Subject: New System Variance to the Maine Subsurface Wastewater Disposal Rules, Northern New England District Council Property, Riverside Street, Portland

NEW SYSTEM VARIANCE REQUEST JUL 19 1984

Subject: New System Variance to the Maine Subsurface Wastewater Disposal Rules, Northern New England District Council property, Riverside Street, Portland

CITY OF PORTLAND, MAINE
SITE PLAN REVIEW
 Processing Form

SURFACE WASTEWATER DISPOSAL SYSTEM APPLICATION
 City, Plantation
 Street, Road, Subdivision
 Owners Name
 Department of Human Services
 Division of Health Engineering
 JUL 19 1984
PORTLAND 487-515 RIVERSIDE ST. ASSEMBLY OF GOD CHURCH.
SUBSURFACE WASTEWATER DISPOSAL PLAN
 Scale 1" = 20' Ft

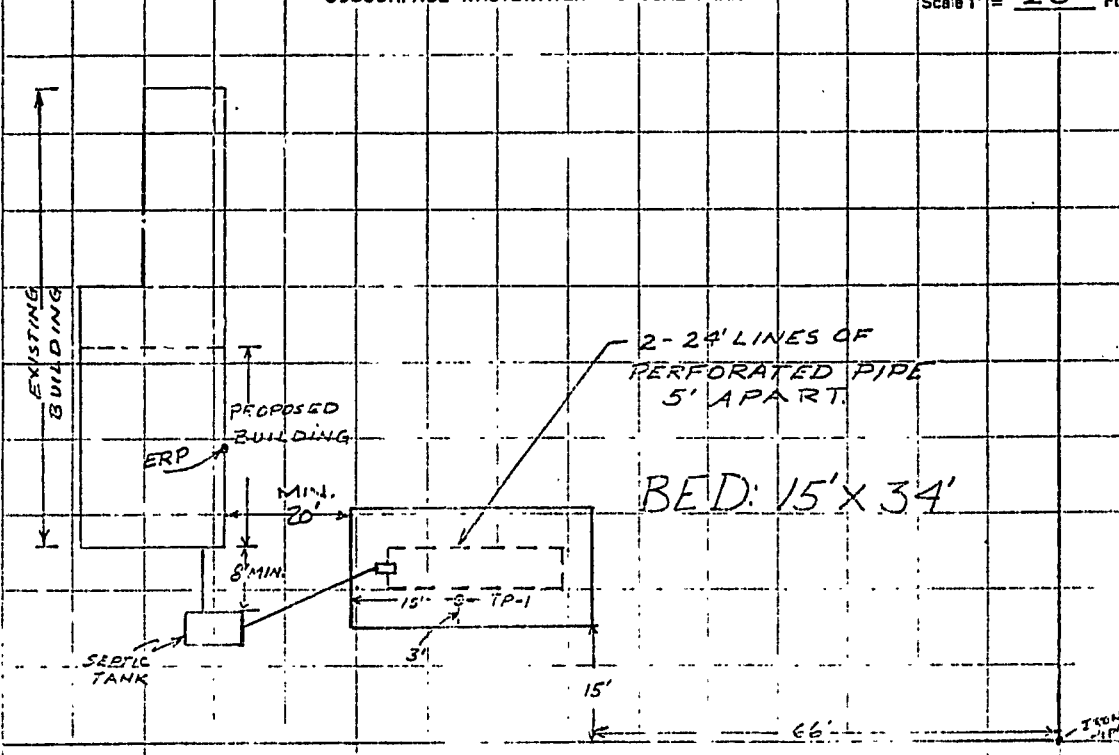
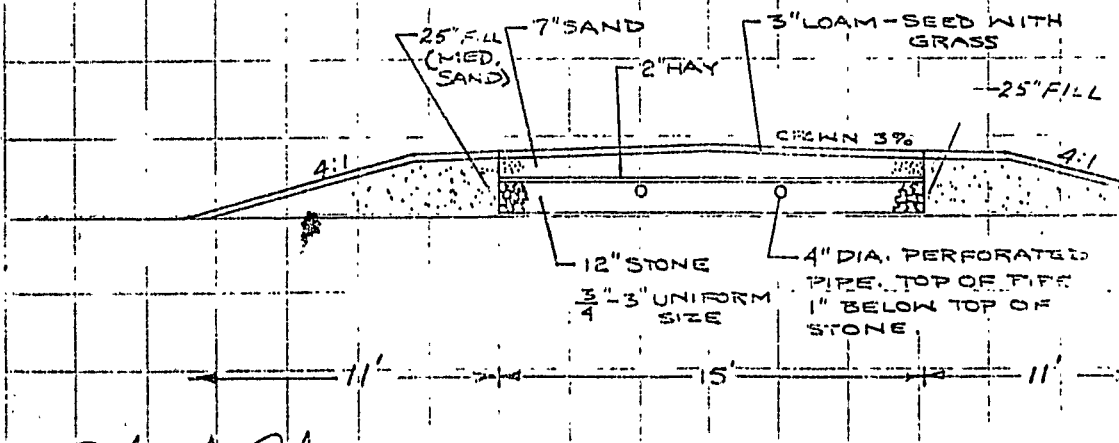
The installation of a 1000 gallon septic tank followed by a 34'x15' bed system.

At least 25 inches and 25 inches of fill shall be applied on the uphill and downhill sides of the disposal field, respectively. The fill shall be of a texture similar to the original soil and will provide a 12 inch separation between the bottom of the disposal bed and the seasonal high water table and impervious layer. The fill must be extended in all directions as required by Section 11.D of the Subsurface Wastewater Disposal Rules.

This office points out that the rules require that the Site Evaluator, Mr. Sweet, be retained to stake out the system and elevations at the time of construction of the system.

SUBSURFACE WASTEWATER DISPOSAL PLAN

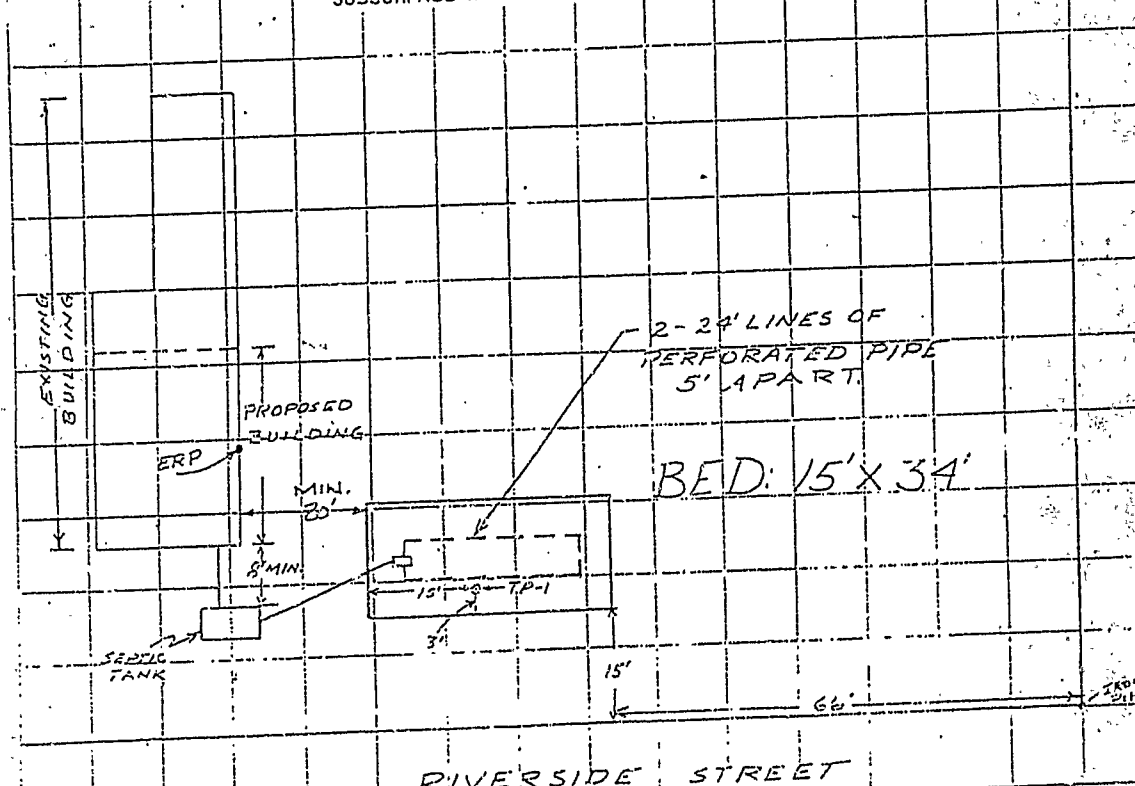
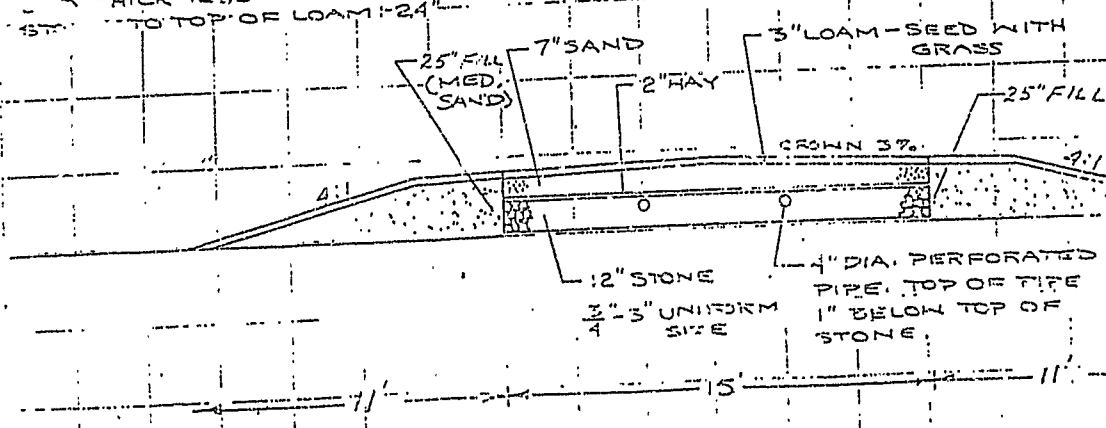
The installation of a 1000 gallon septic tank followed by a 34'x15' bed system.

At least 25 inches and 25 inches of fill shall be applied on the uphill and downhill sides of the disposal field, respectively. The fill shall be of a texture similar to the original soil and will provide a 12 inch separation between the bottom of the disposal bed and the seasonal high water table and impervious layer. The fill must be extended in all directions as required by Section 11.D of the Subsurface Wastewater Disposal Rules.

This office points out that the rules require that the Site Evaluator, Mr. Sweet, be retained to stake out the system and elevations at the time of construction of the system.
